Project Name	BCWD Permit 25-05 St. Croix Recreation Center	Date	4/4/2025
To / Contact info	BCWD Board of Managers		
Cc / Contact info	Reabar Abdullah, PE; Dillon McClung / City of Stillwater		
Cc / Contact info	Karen Kill, Administrator / BCWD		
From / Contact info	Ryan Fleming, PE; Julia Lau, EIT / EOR		
Regarding	Permit Application No. 25-05 Engineer's Report

Figure 1: St. Croix Valley Recreation Center Site Plan

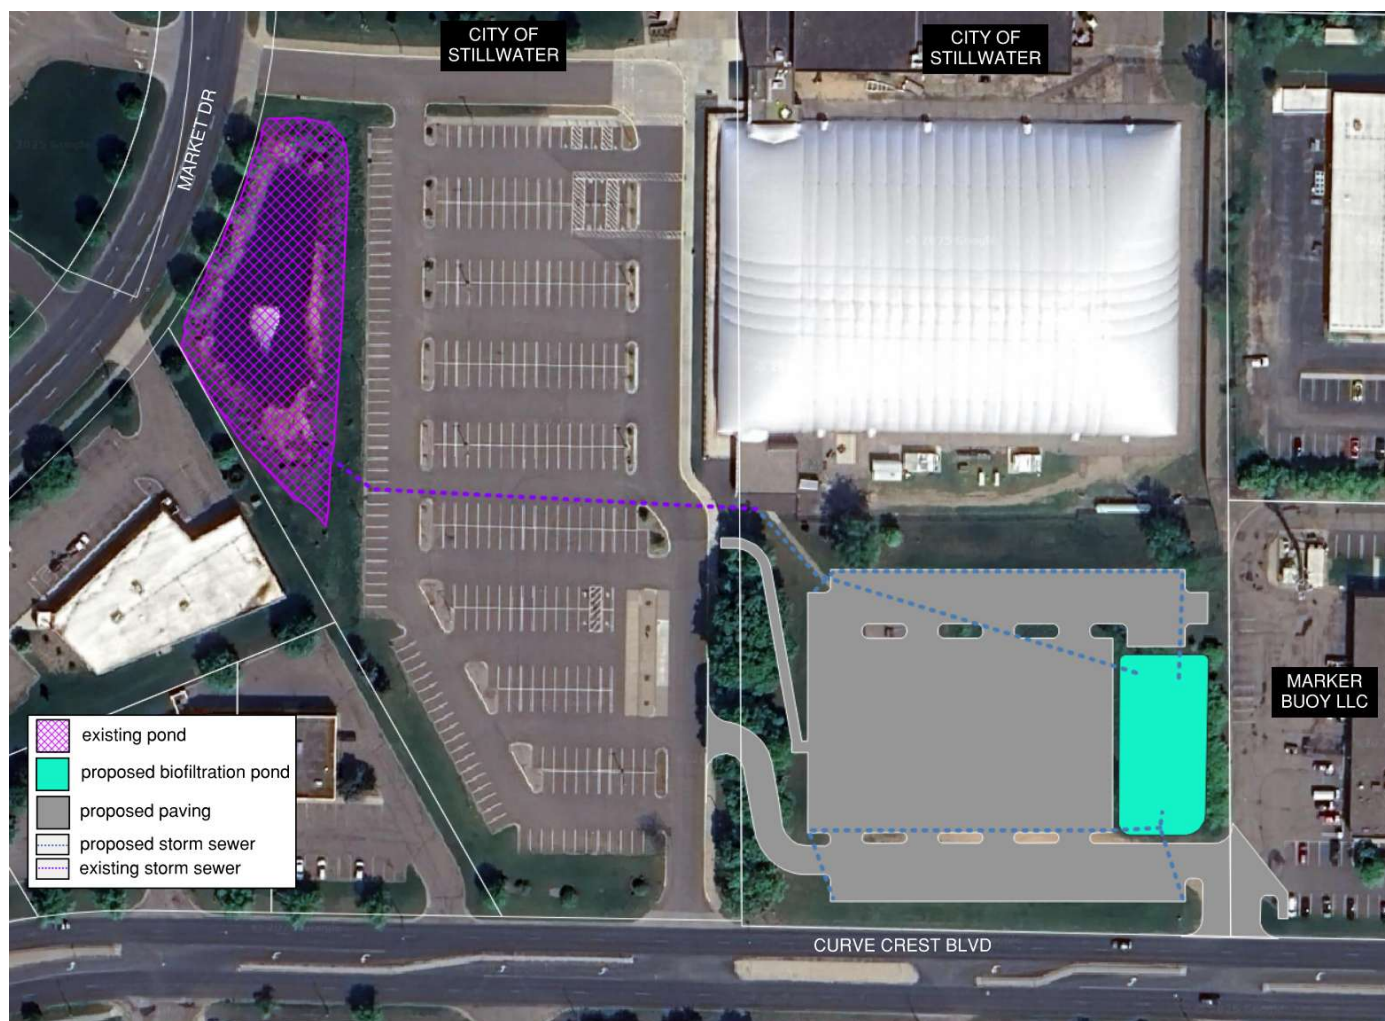
Proposed Conditions: The project will replace the existing skate park with a parking lot, sidewalk, a biofiltration basin, and driveways connecting west to the adjacent parking lot and south to Curve Crest Boulevard (Figure 1). Storm sewer will be added in the proposed parking lot to convey runoff to the biofiltration basin, then to the existing stormwater pond on the west side of the existing parking lot. The project will disturb approximately 3.13 acres. The entire 0.37 acres of existing impervious will be removed and the total proposed impervious area will be 1.85 acres of the 3.13-acre disturbance.
